Access Compliance Report Public Rights-of-Way (Curb Ramps)

Main Street: STARLIGHT_RIDGE		Cross Street: SUMMIT_CT		Location:	SE
ADA ID: RPRK211018173742	Ramp Type: Type 4 - Parallel	Initial Pass/Fail: Fail	Overall Compliance: No	Severity Score:	30
Codes/Mitigation Info/Possible Solution			Field Measurements/Component Compliance

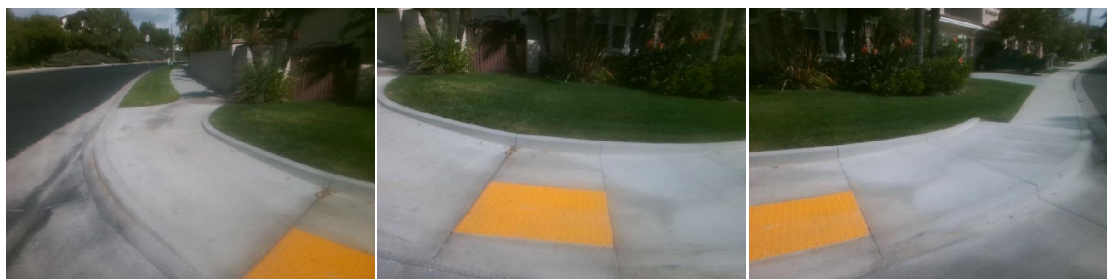
R204.3, R304.3.2, STD 1115

Remove & Replace Curb Ramp With Two New Directional Ramps or Equivalent.
